PROPOSED WRECK REMOVAL TECHNIQUES

MV “RENA”, WRECKED ON ASTROLABE REEF

AS CONTAINED IN THE OWNER’S RMA APPLICATION

Date: 18 August 2014

Figure 1. RSF Debris Field Survey April 2014.

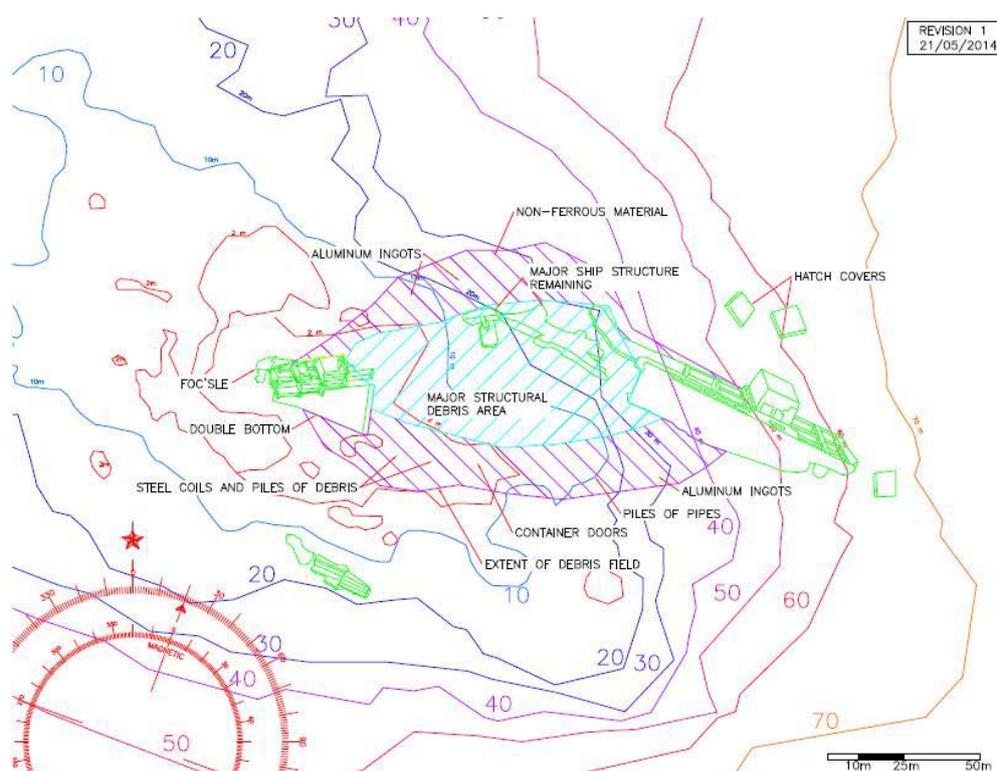
Figure 1 at paragraph 3.2.9 of this report shows the relative small size of the footprint of the actual wreck as compared to the large footprint of the debris fields (both major and minor) therefore the argument raised in point 1 above
